Re: **SCI-823-6.81, Portsmouth Bypass Project, PID 19415**
Addendum to Report: Lucasville-Minford Road (CR 28) Interchange
Embankment Stability, Time-Rate of Consolidation, Soil Cut Slope Stability, and Subgrade
Treatment
DLZ Job No.: 0121-3070.03, Document No. 108

DLZ has reviewed ODOT-Office of Geotechnical Engineering's (OGE's) Stage I review comments (dated January 31, 2007) for Phase I of the SCI-823 project. In compliance with the review comments, DLZ has modified the slope stability analyses and time-rate of consolidation calculations for the Lucasville-Minford Road (CR 28) interchange embankments. This document also presents recommendations for soil cut slopes, and subgrade treatment for the interchange mainline roadway and ramp alignments contained within the interchange.

Ramp D 522+50 Soil Cut Drained Seismic
 SCI-823 Lucasville-Minford Soil Cut, Ramp D Sta. 522+50
 Analysis Method: bishop simplified

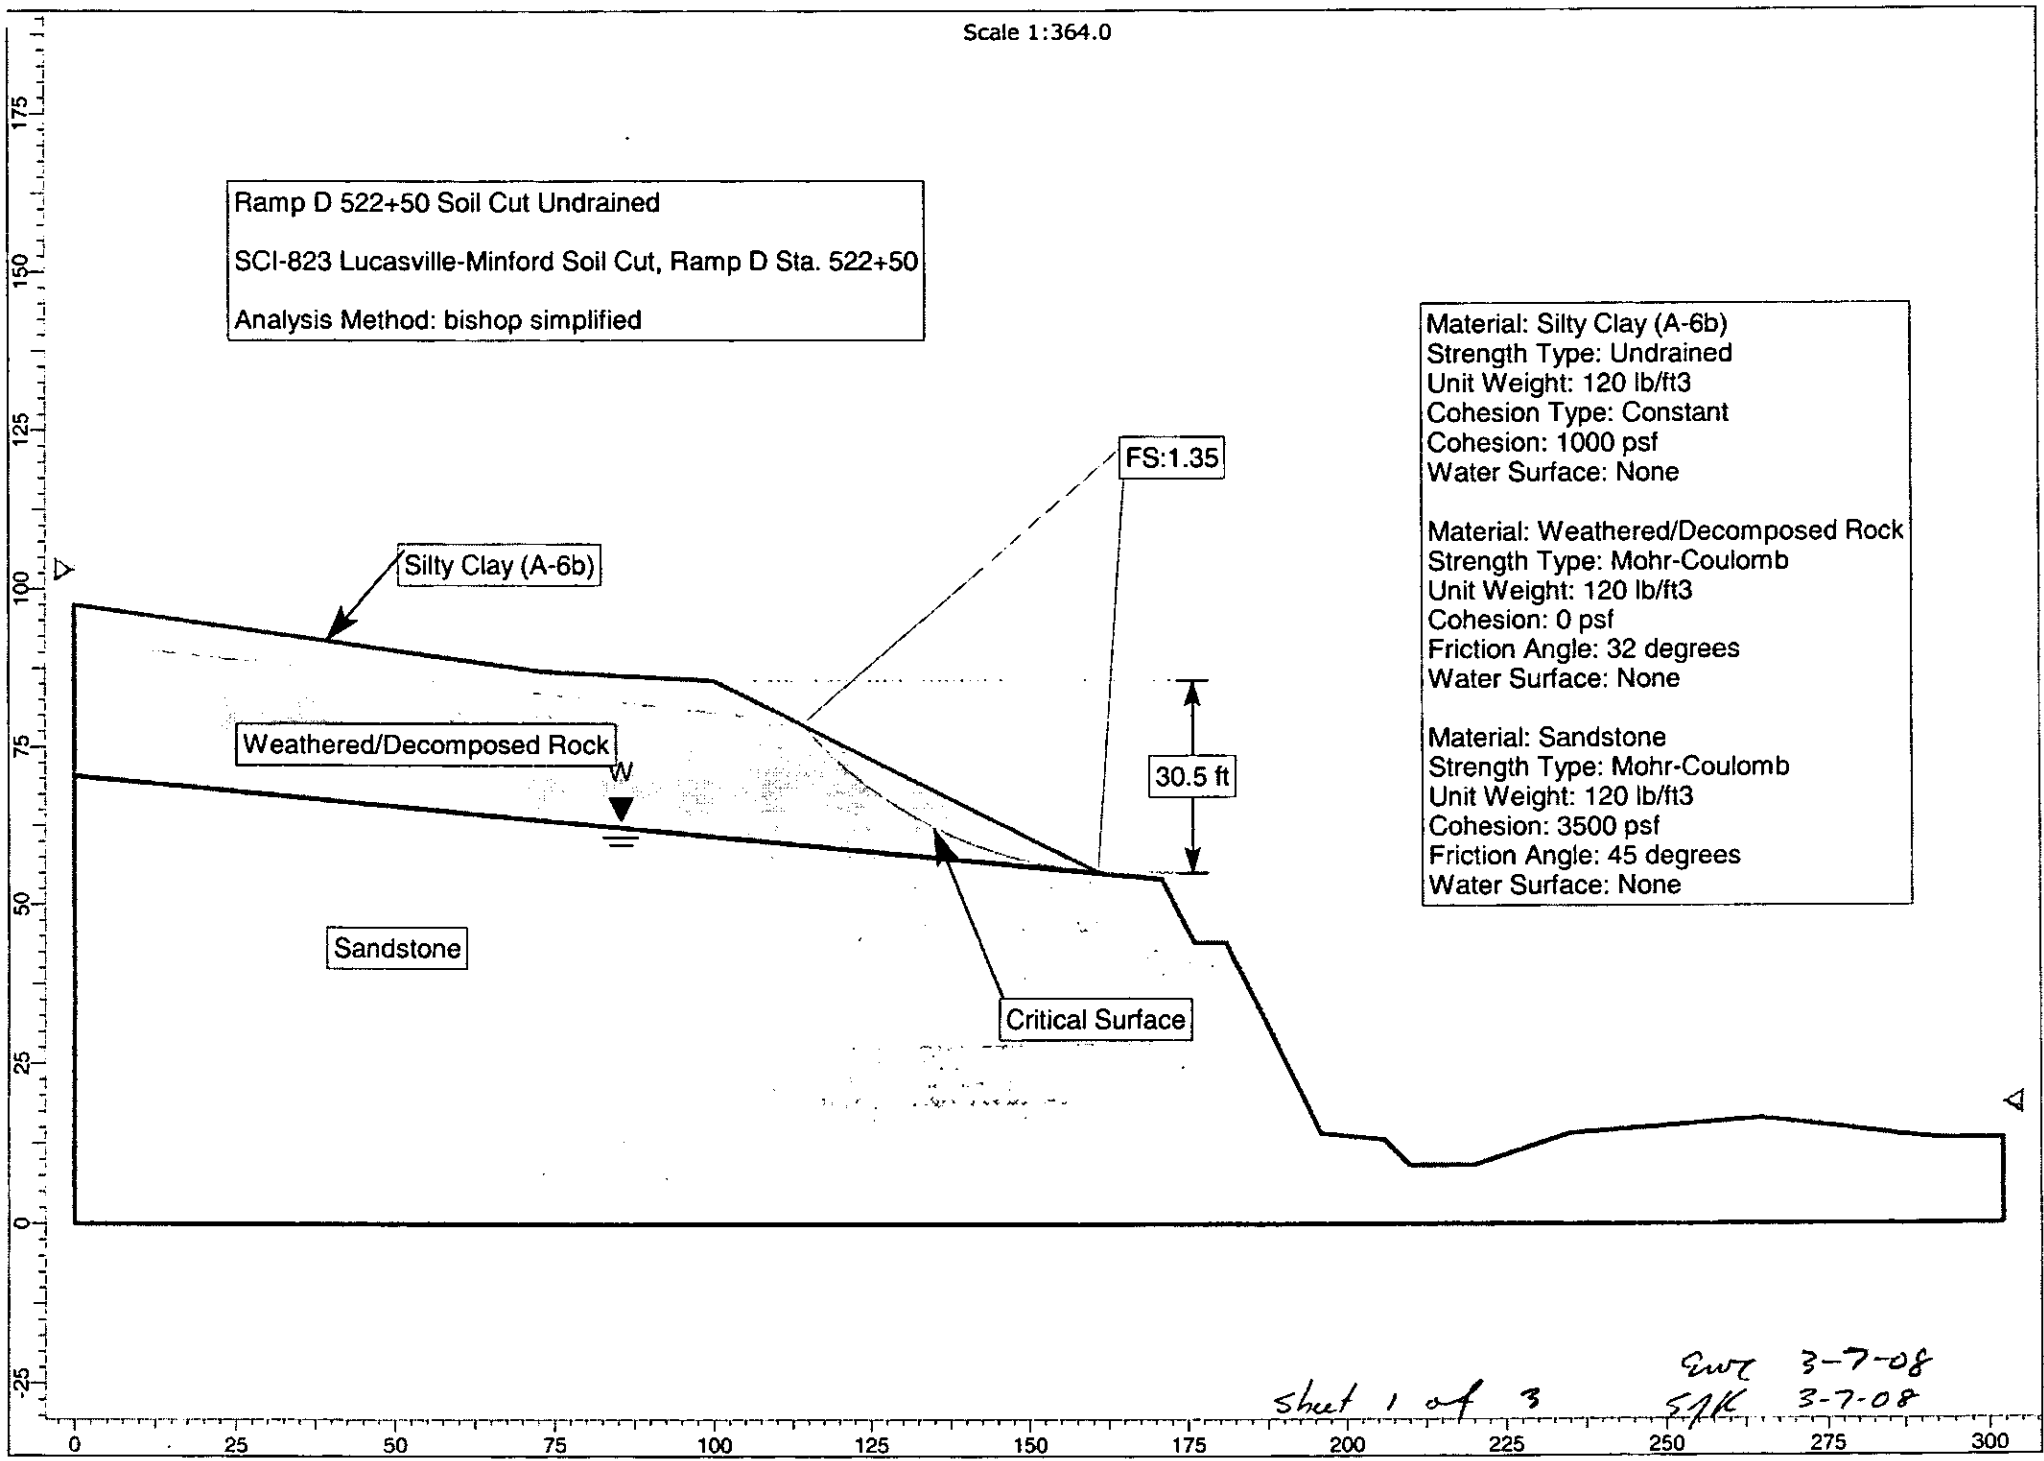
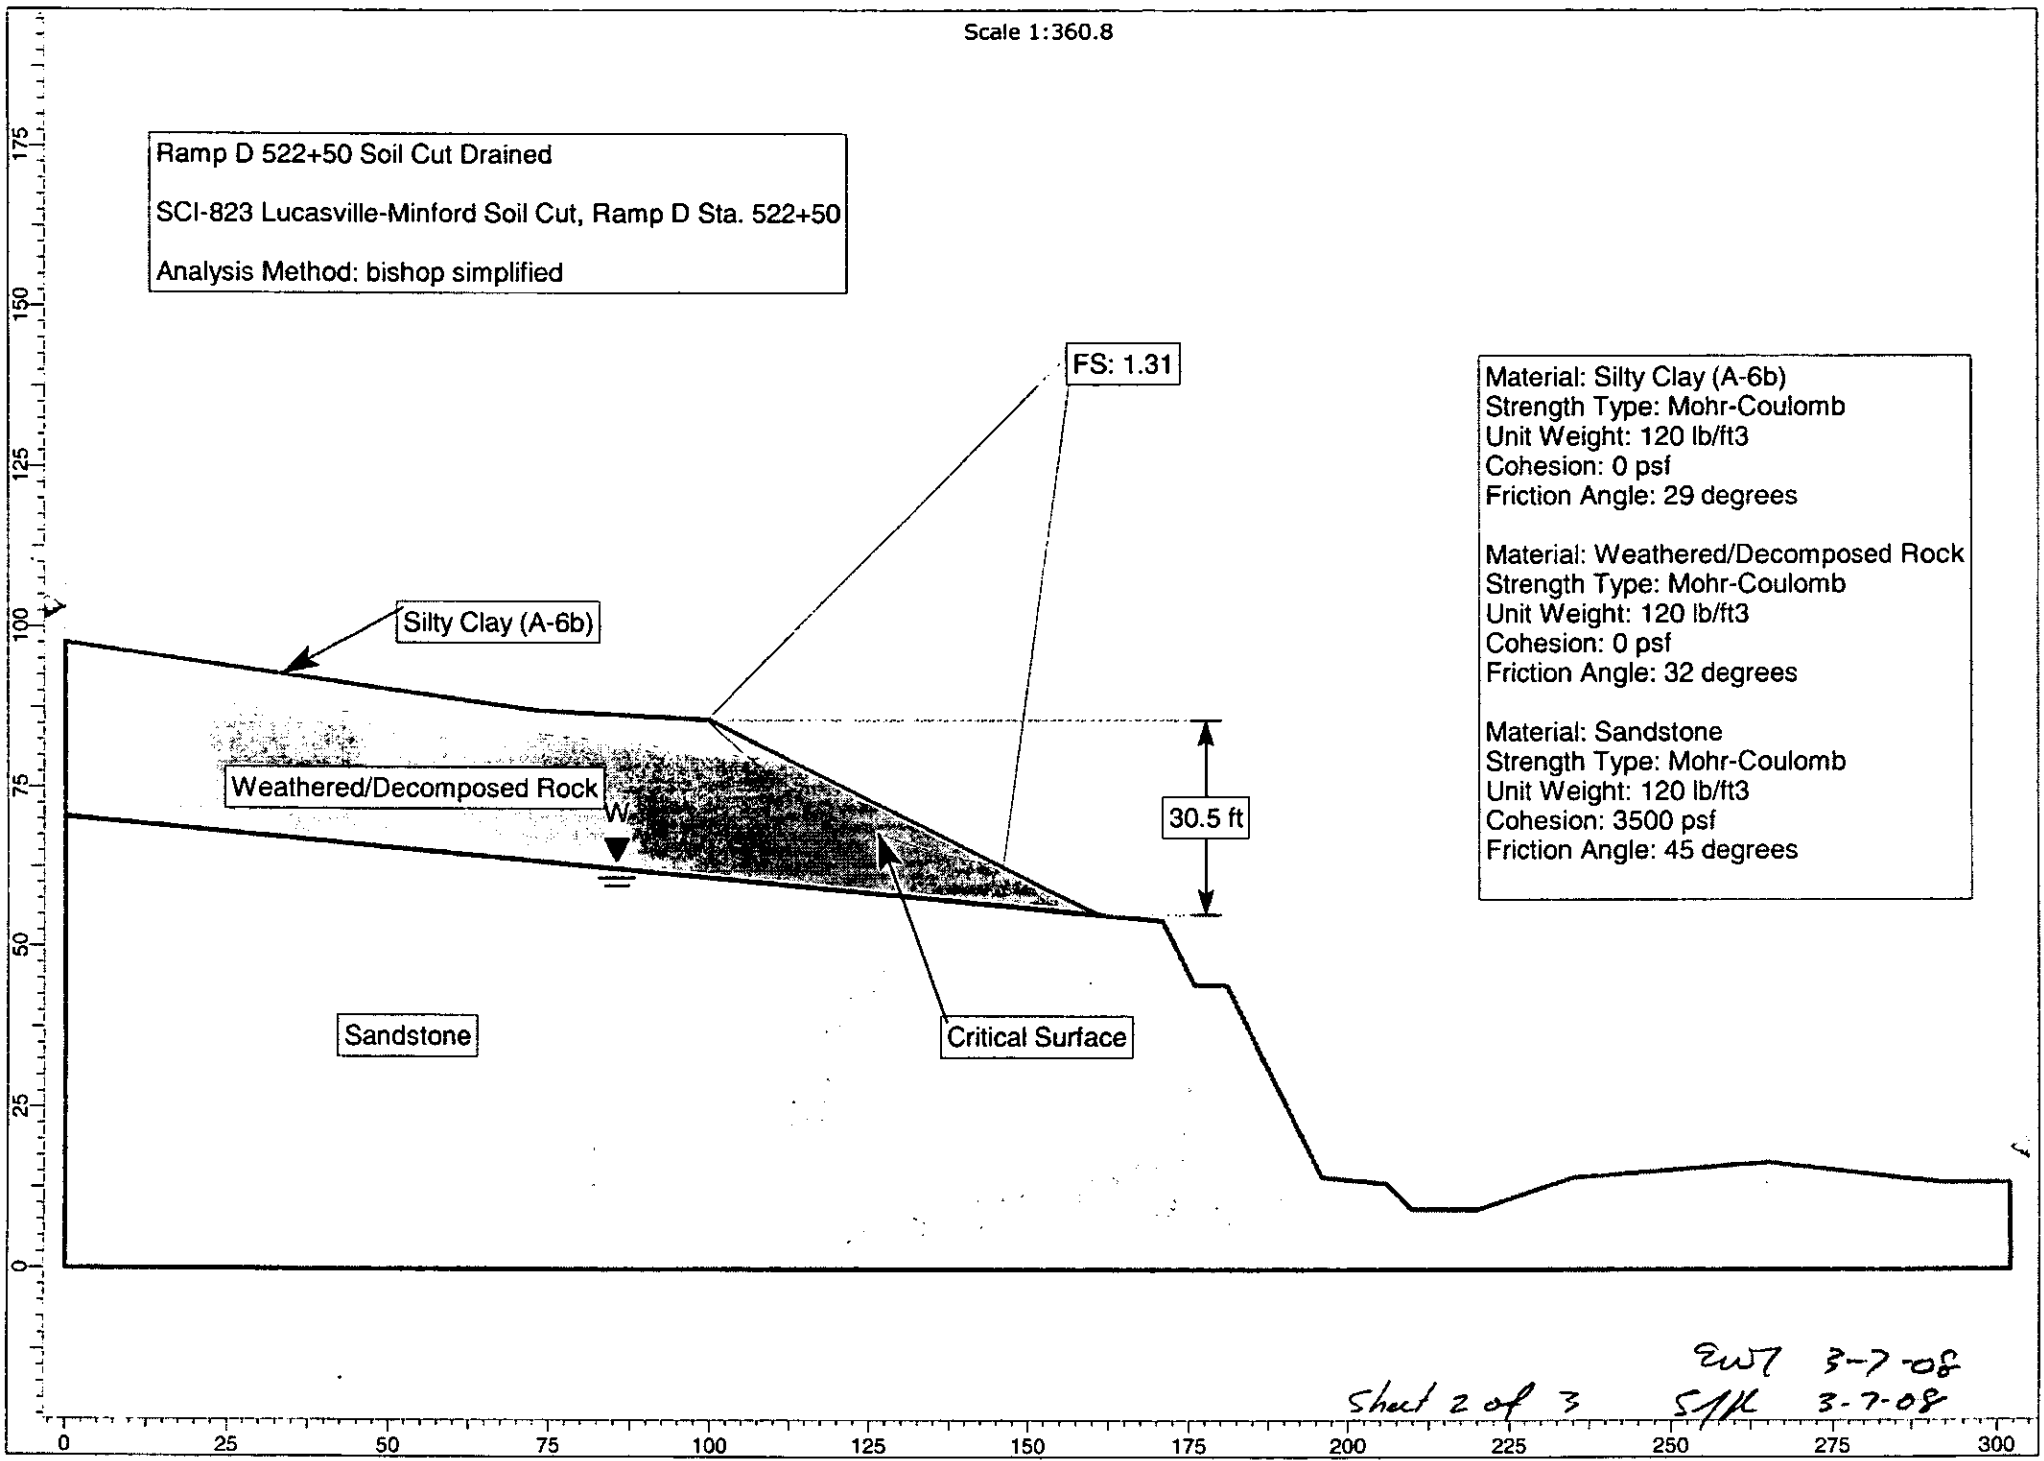
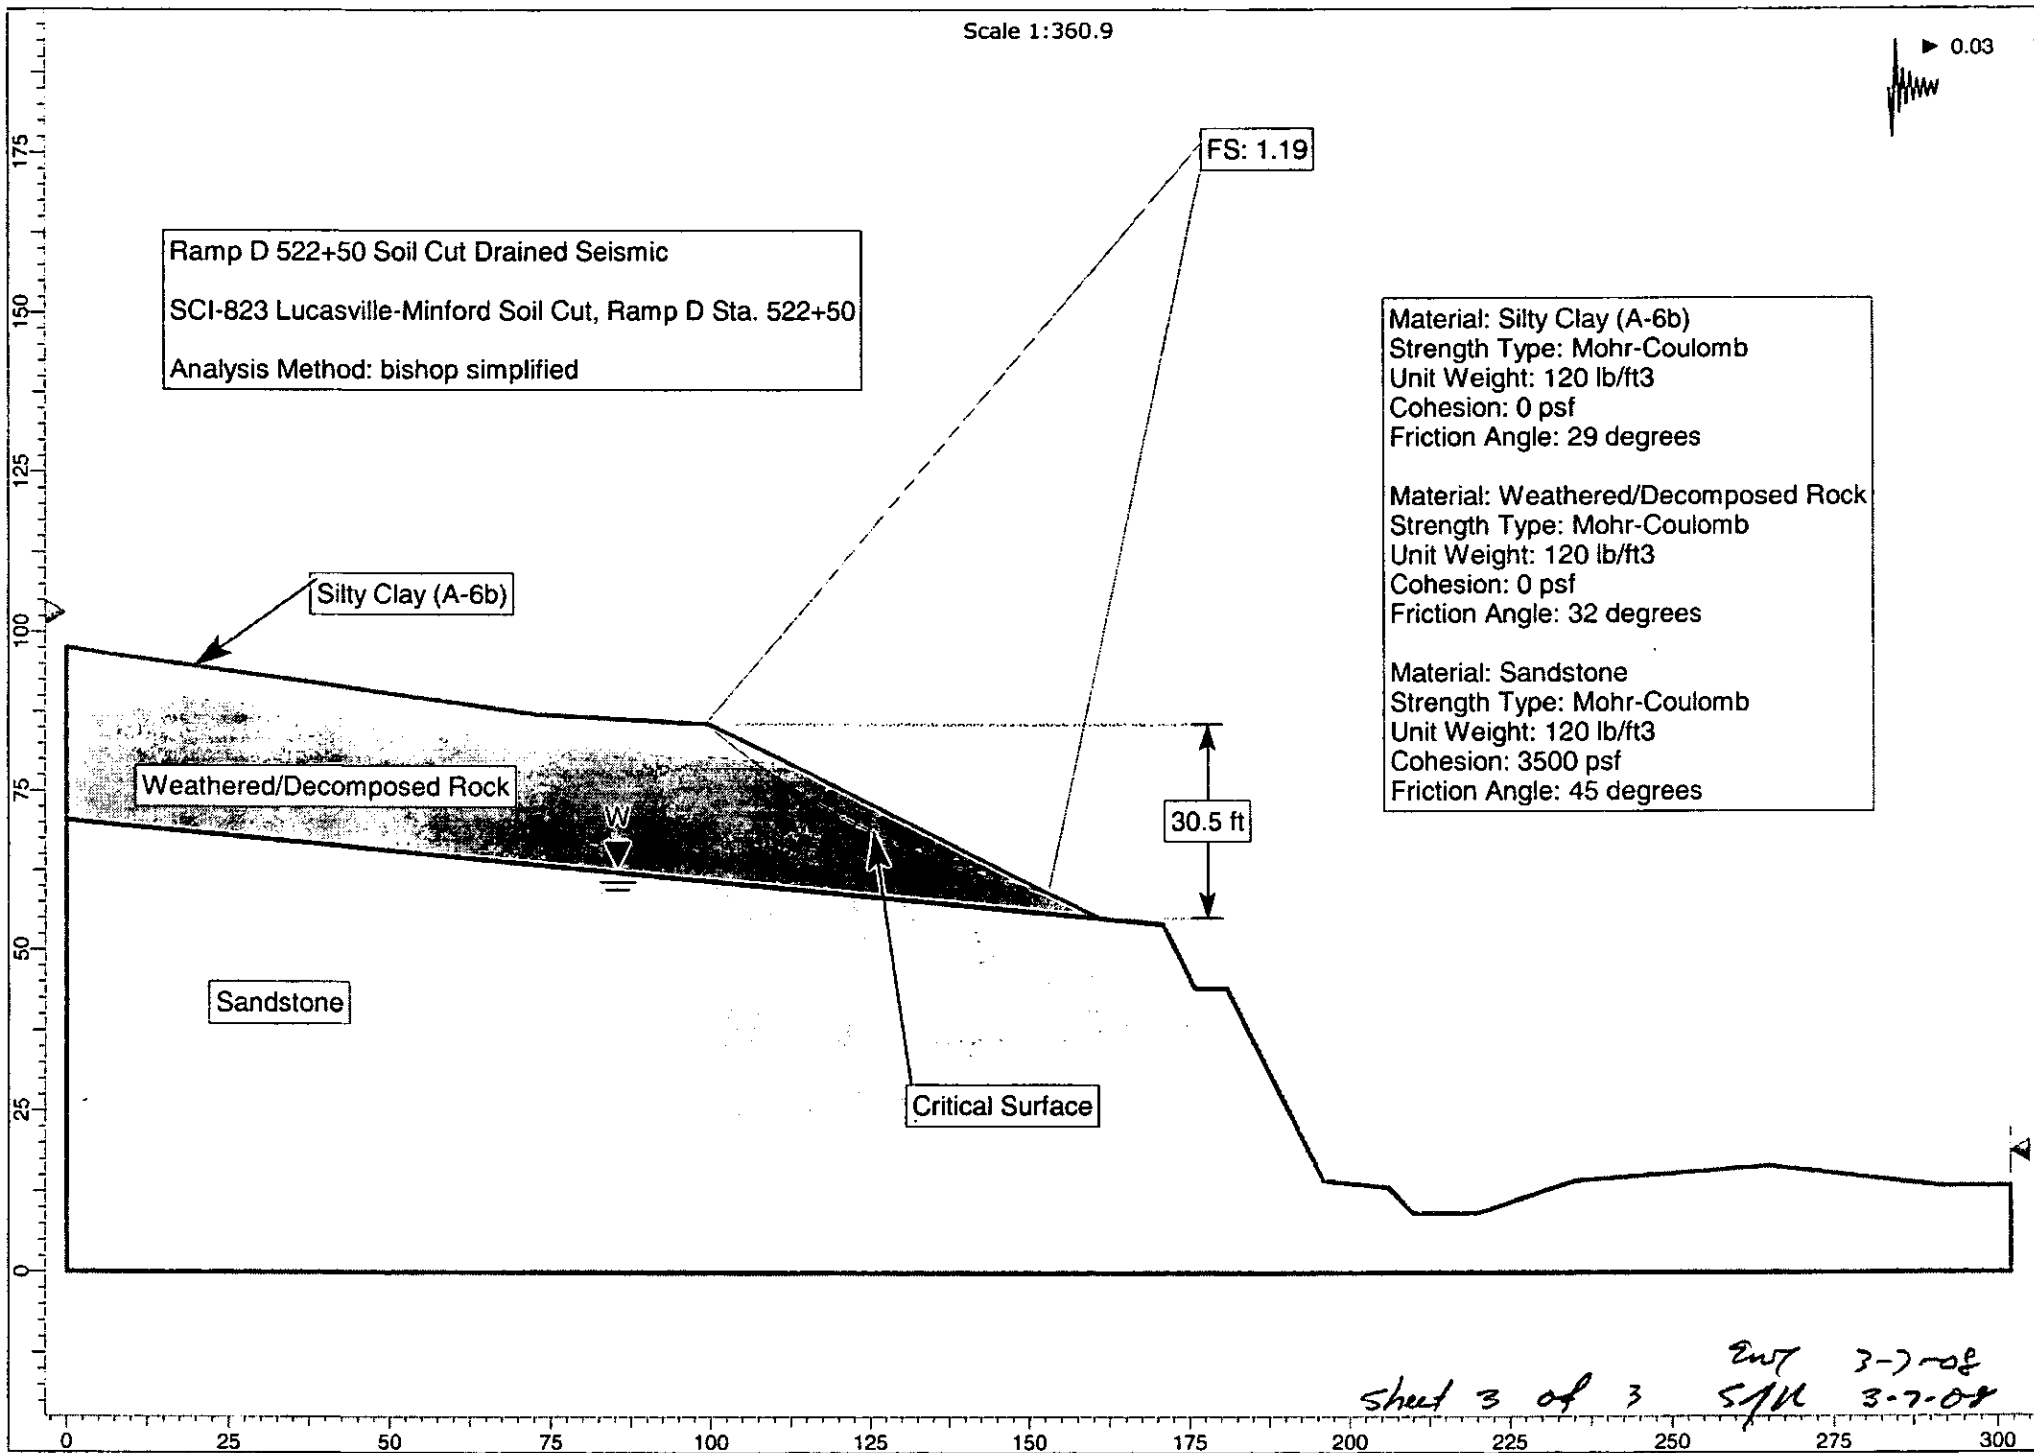
- OGE stated that DLZ should evaluate soil cut slopes in the interchange to ensure that the recommended use of 2H:1V slopes in the soil cuts is adequate.

The soil cut at Ramp D station 522+50 was evaluated for stability. This cut in soil is assumed to be approximately 30.5 feet high. The subsurface conditions encountered by boring R-457 are assumed for these analyses. The undrained and drained conditions yielded critical factors of safety of 1.35 and 1.31, respectively. The results of the stability analyses indicate that the use of 2H:1V slopes are acceptable. The results of the stability analyses are attached.

- The stability of the soil cut slopes in the interchange area were evaluated for stability. The analyses indicate that 2H:1V slopes in soil cuts are stable. The results of the stability analyses are attached.
- The mainline and ramp subgrades in the interchange were evaluated to determine the proper course of subgrade mediation as per Geotechnical Bulletin No1 (GB1). Several areas require treatment to ensure a stable subgrade is provided. Refer to the Subgrade Recommendations section for more information.
